HISTORIC PRESERVATION COMMISSION

STAFF REPORT
Department of Growth Management

MEETING DATE:	November 2, 2016
PROJECT:	1321 May River Rd. (Lot 1, CSP) – New Construction
APPLICANT:	Kevin Grenier, KRA, Inc.
PROJECT MANAGER:	Erin Schumacher, AICP, Senior Planner

PLAN REVIEW COMMENTS FOR COFA-08-16-010035

1 AS1.0 SITE PLAN
SCALE: 1 : 8

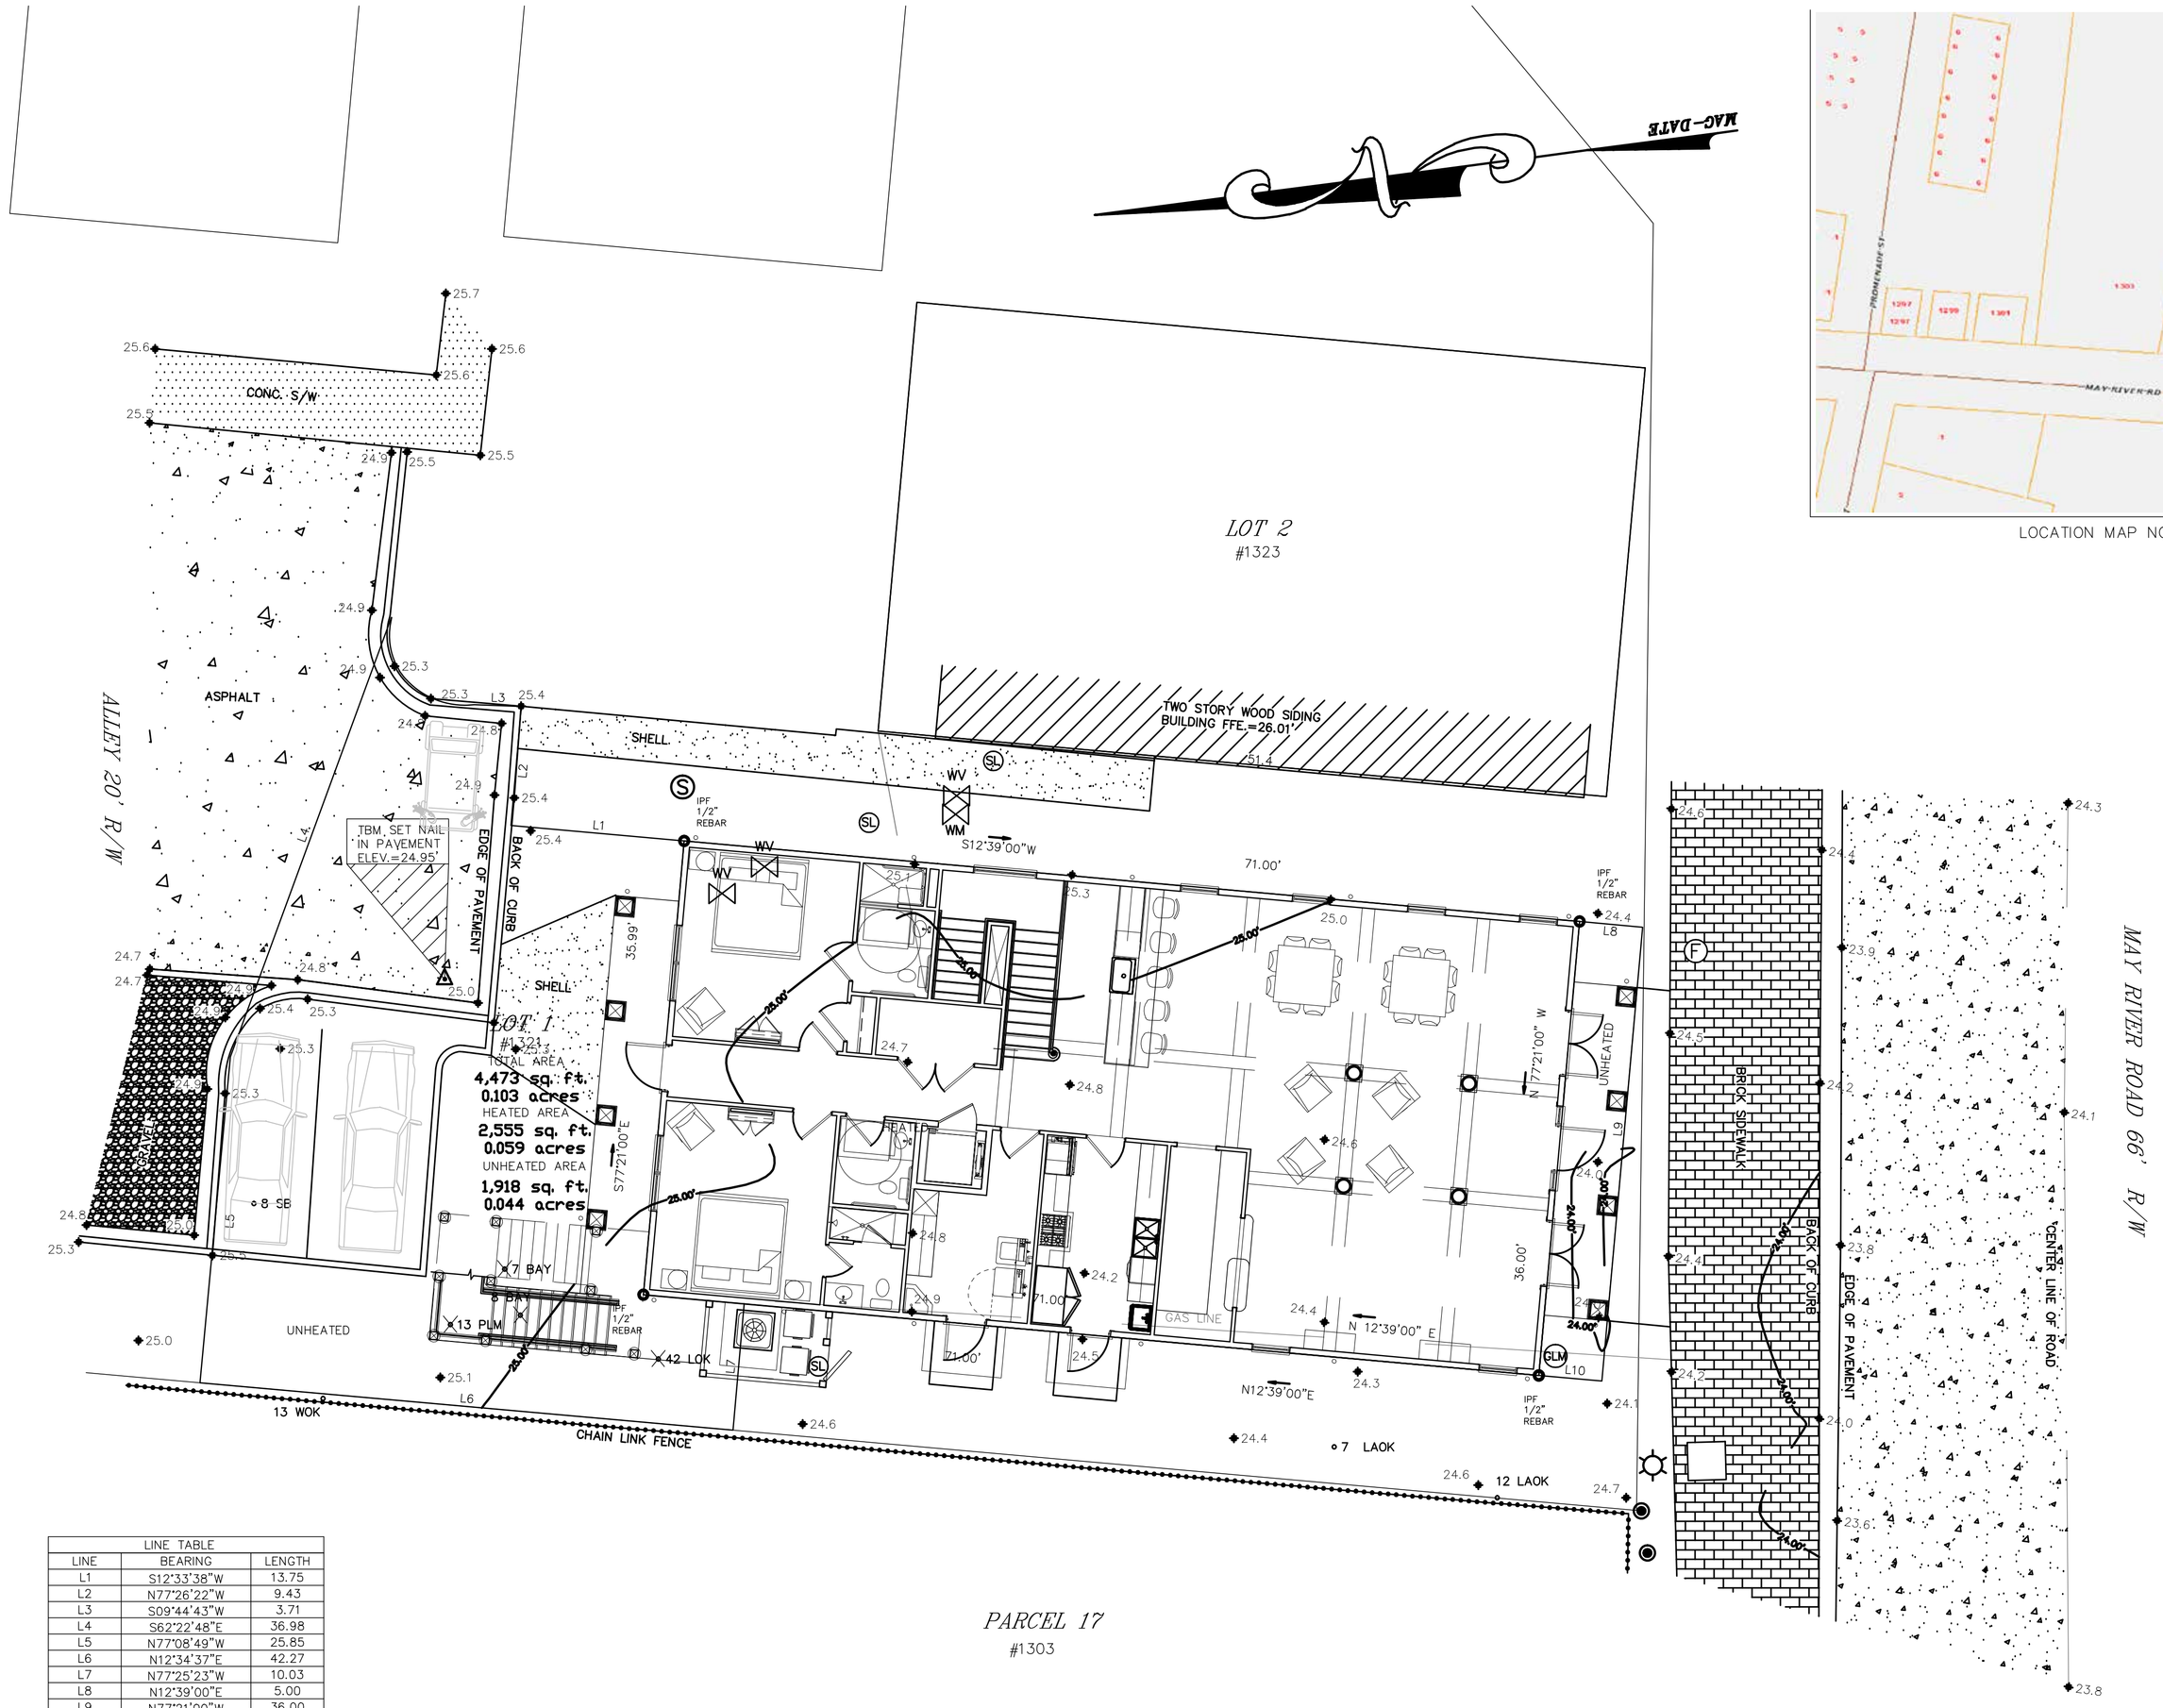
Further, the Exempt Plat approved on March 3, 2016, indicates a hatched area north and south of the building pad with a note stating "the hatched are will not be developed with additional structures or parking without a development permit." As the proposed structure includes portions of the building (stairs, balconies, and service yards) as well as parking which is noted on the Site Plan within this hatched area, a development plan amendment must be submitted for review and approval by the Town of Bluffton Development Review Committee (DRC).

1) Section 5.3.7.A. – Street Trees. The UDO requires that all roadways on which development is proposed shall include large canopy street trees that are planted no greater than 50 feet apart. There is an existing 12" Laurel Oak noted on the site plan which would meet this requirement; however, the tree removal permit which was submitted to the Town of Bluffton which is currently under review indicates the removal of a Laurel Oak at the front of the lot. If this tree is removed,

a new large canopy street tree will be required to be installed along the roadway to satisfy the requirements of the UDO.

1. Per the Applications Manual, and to be in accordance with the Exempt Plat approved on March 3, 2016, a development plan amendment must be submitted for review and approval by the Town of Bluffton Development Review Committee (DRC) to allow for proposed structures and parking noted on the Site Plan. Any and all comments provided by the DRC must be addressed prior to the issuance of a Certificate of Appropriateness.

2. Per Section 5.3.7.A. of the UDO, if the 12" Laurel Oak noted at the front of the lot is removed, a new large canopy street tree will be required to be installed along the roadway to satisfy the street tree requirements of the UDO.

4 A4.0 GABLE END DETAIL
SCALE: 3 / 4 " = 1 ' - 0 "

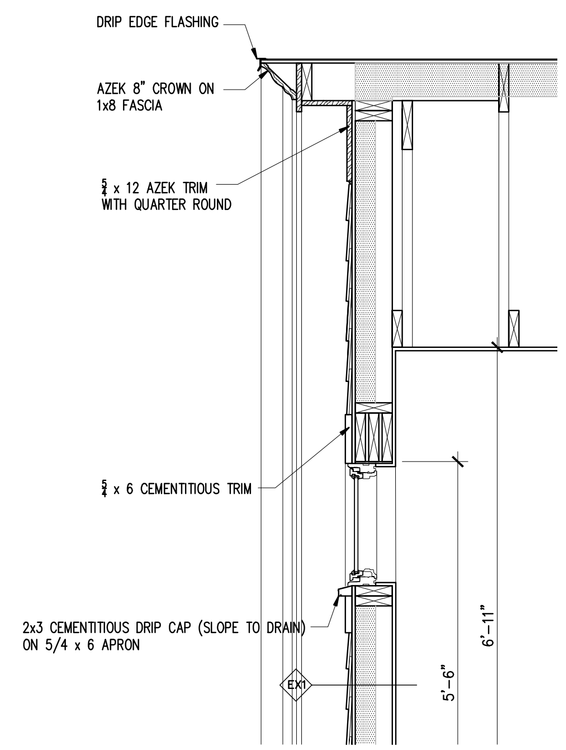
4) UDO Section 5.15.6.A. & 5.15.6.I.3.a. - Architectural Standards & Windows and Doors. The UDO permits rectangular, square, transom, and sidelight window configurations. The proposal indicates the use of a fanlight window configuration in the main gable. This configuration must be reviewed and approved by the HPC as an appropriate substitute for the permitted configurations.

5. Per Section 5.15.6.A. & 5.15.6.I.3.a. of the UDO, the use of a fanlight window configuration in the main gable must be reviewed and approved by the HPC as an appropriate substitute for those configurations permitted.
